24TH AVE. S.E.

AREA I

PLAN AS-BUILT CORRECTIONS  
DATE: 11-05-28  
BY: JRM

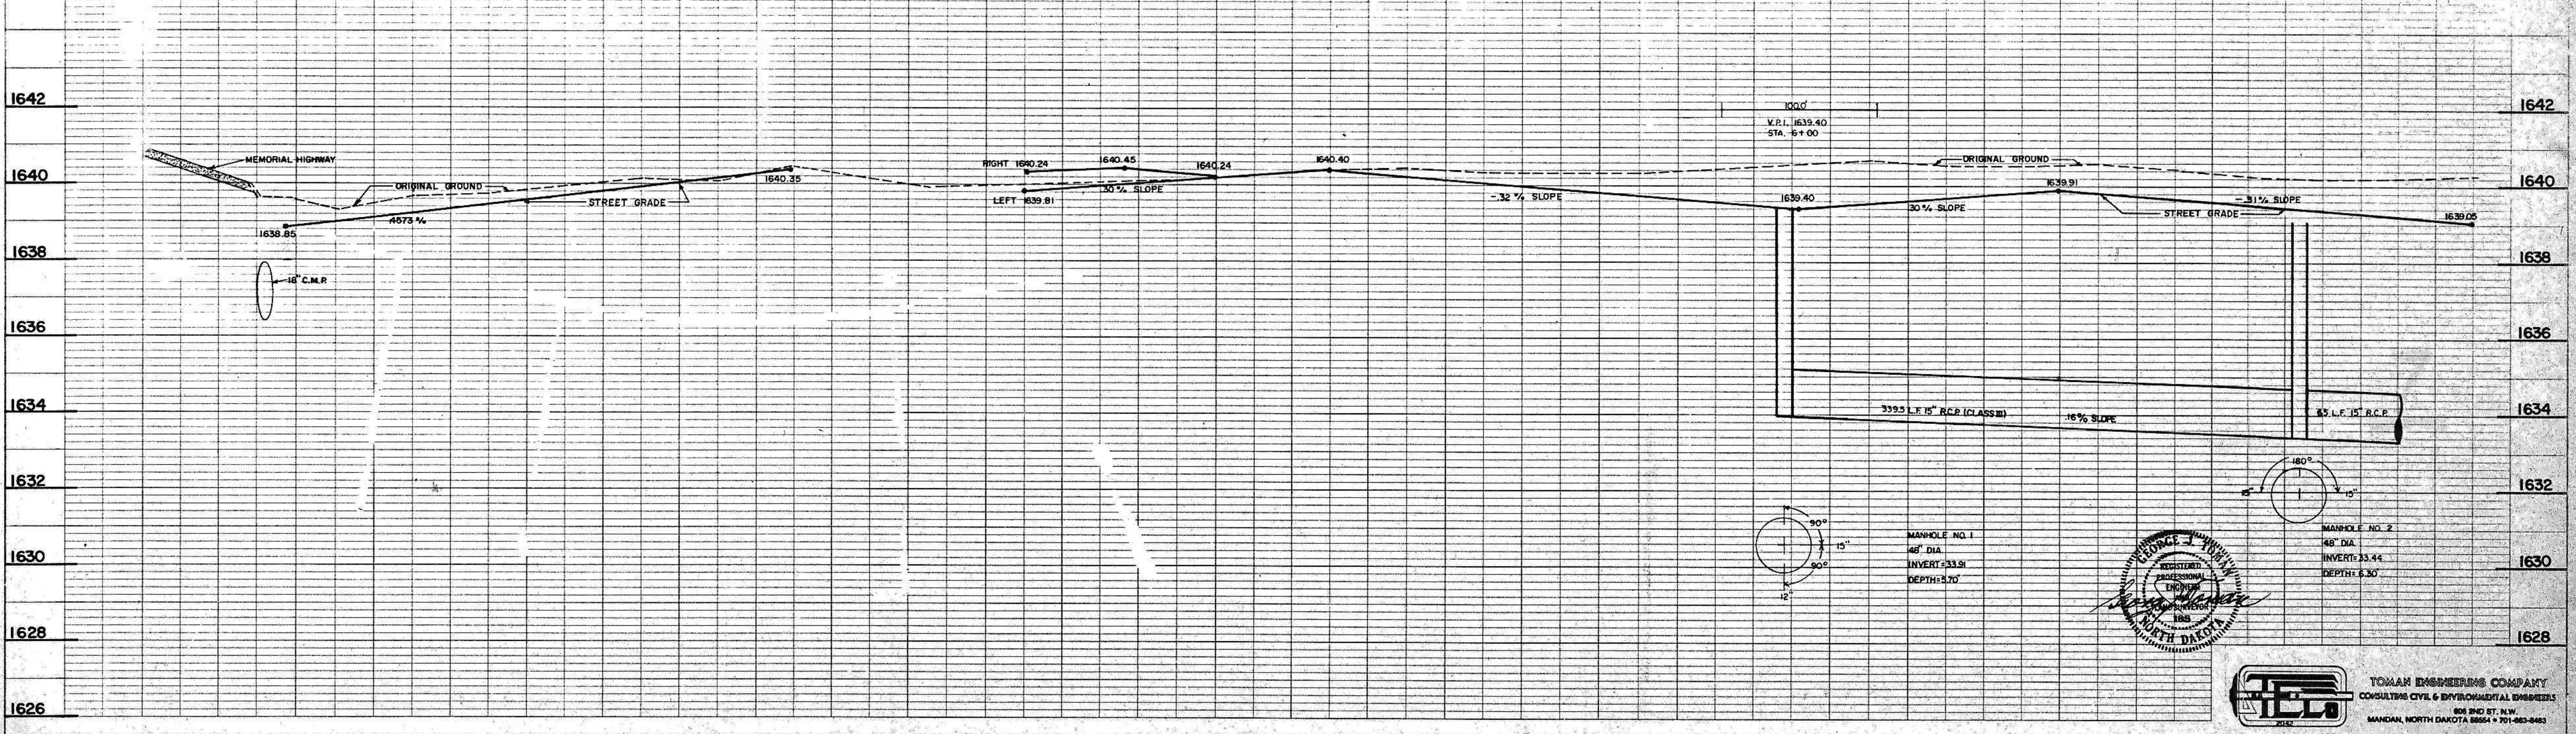
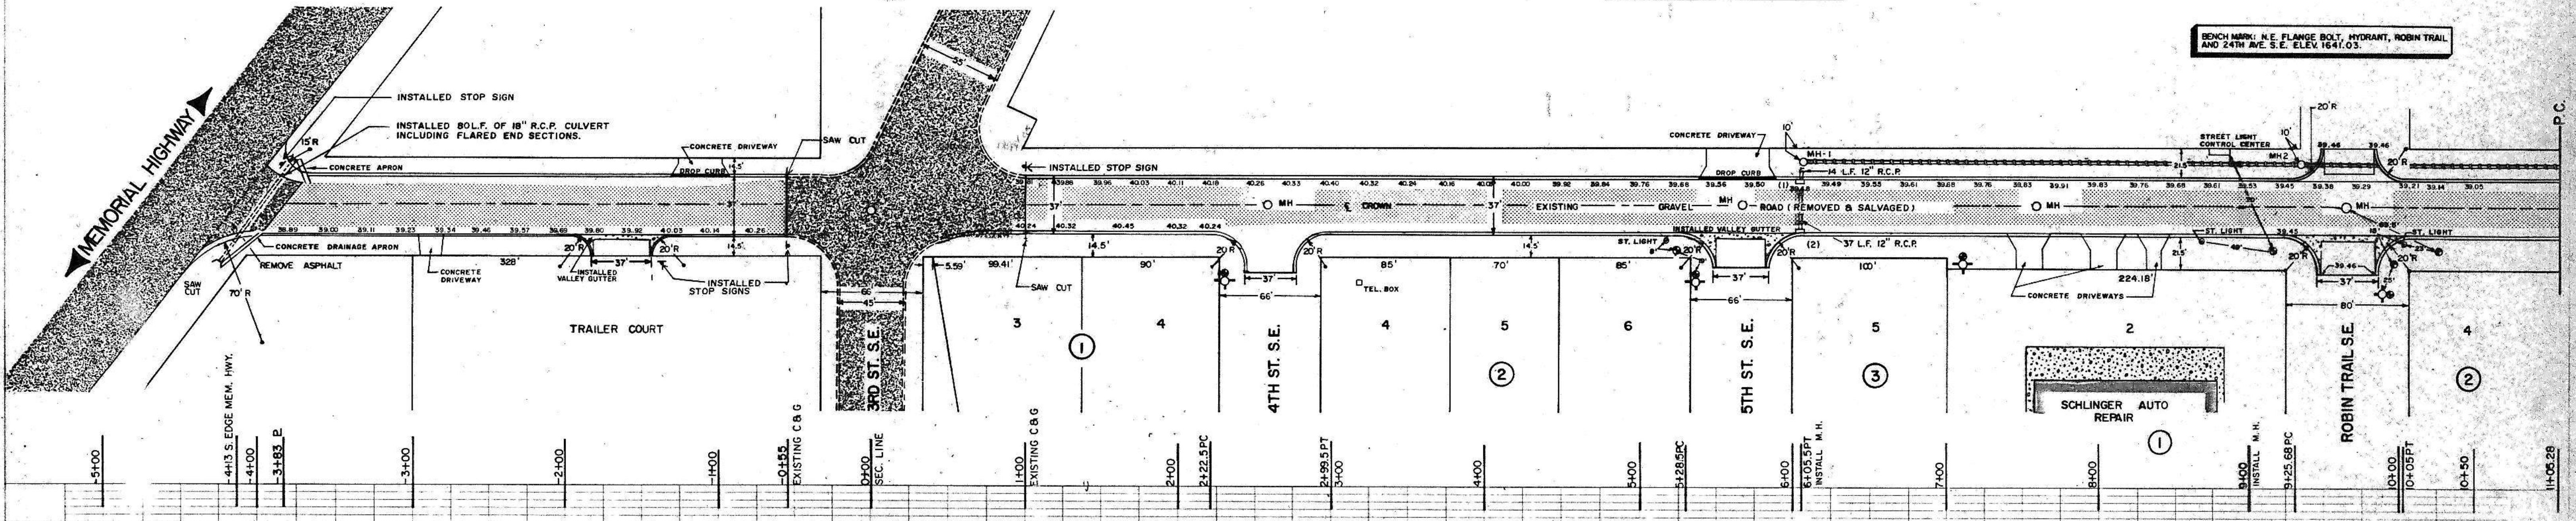
PROFILE  
DATE: 11-05-28  
BY: JRM
